Subject ▶ Change of Anvil

For Models ▶ 6905H, SI100

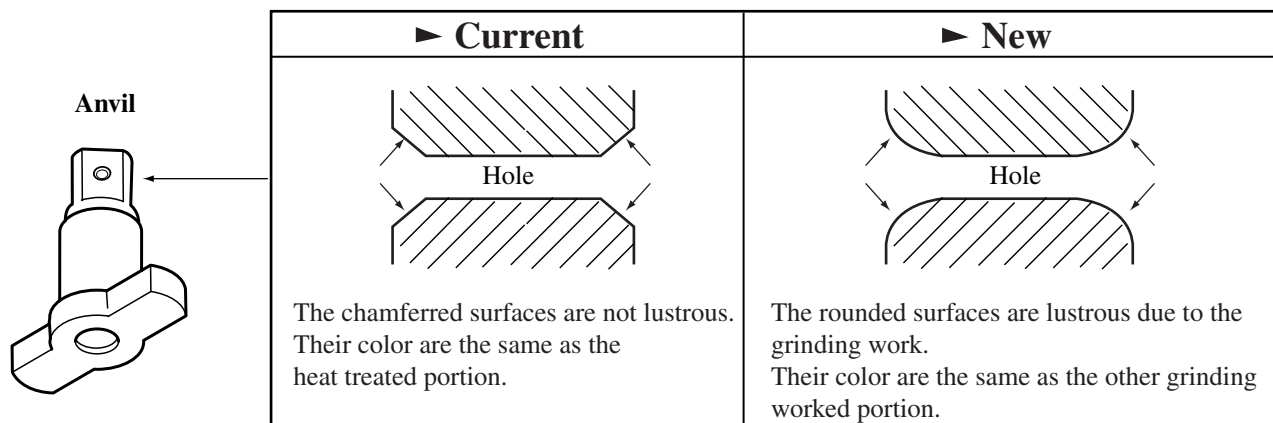
Description ▶ As illustrated below, grinding work has been added onto the circumferences of hole after heat treatment.

Item No.	Current part		Q'ty	I/C	New part		Q'ty	Note
017	Anvil 322503-7		1	←	Anvil 324357-8		1	For all countries

Item No.	Current part		Q'ty	I/C	New part		Q'ty	Note
015	Anvil 322503-7		1	←	Anvil 324357-8		1	For all countries except Canada, U.S.A., Mexico, Panama
015	Anvil 322504-5		1	←	Anvil 324358-6		1	For Canada, U.S.A., Mexico, Panama
